DEPARTMENT OF TRANSPORTATION**DIVISION OF ENGINEERING SERVICES**

Contract #: 04-0120F4Cty: SF/ALA Rte: 80 PM: 13.2/13.9File #: 69.28**WELDING INSPECTION REPORT****Resident Engineer:**Siegenthaler, Peter**Address:** 333 Burma Road**City:** Oakland, CA 94607**Report No:** WIR-024031**Date Inspected:** 21-Apr-2011**Project Name:** SAS Superstructure**OSM Arrival Time:** 700**Prime Contractor:** American Bridge/Fluor Enterprises, a JV**OSM Departure Time:** 1900**Contractor:** Zhenhua Port Machinery Company, Ltd (ZPMC), Changxing Island **Location:** Shanghai, China**CWI Name:** Xu Le Feng**CWI Present:** Yes No**Inspected CWI report:** Yes No N/A**Rod Oven in Use:** Yes No N/A**Electrode to specification:** Yes No N/A**Weld Procedures Followed:** Yes No N/A**Qualified Welders:** Yes No N/A**Verified Joint Fit-up:** Yes No N/A**Approved Drawings:** Yes No N/A**Approved WPS:** Yes No N/A**Delayed / Cancelled:** Yes No N/A**Bridge No:** 34-0006**Component:** TOWER Components**Summary of Items Observed:**

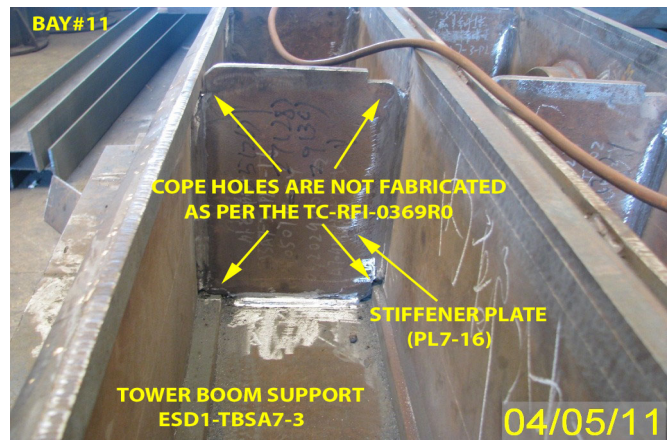
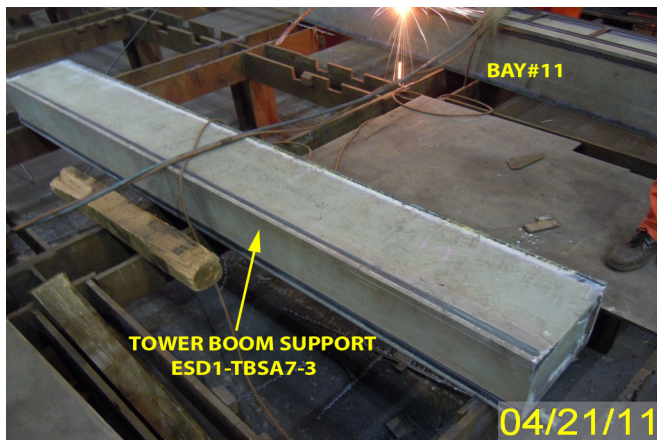
During the Caltrans Quality Assurance (QA) in-process observation on lift-6 tower boom supports, this QA Inspector discovered the following issue:

- ZPMC personnel sealed the Tower Boom Supports without allowing for QA visual confirmation that these corrections had been completed.
- On date: 4/5/2011 it was observed that the cope hole sizes at all 4 corners on every stiffener plate of Tower Boom Supports (listed below) did not conform to shop drawing#PL7-16. (cope holes 25mm x 25mm)
- Cope hole dimensions were then changed to 15mm x 45mm per TC-RFI-369R0 to address this discrepancy.
- The tower boom supports are identified as:-

1. ESD1-TBSA7-3

2. NSD1-TBSA7-3
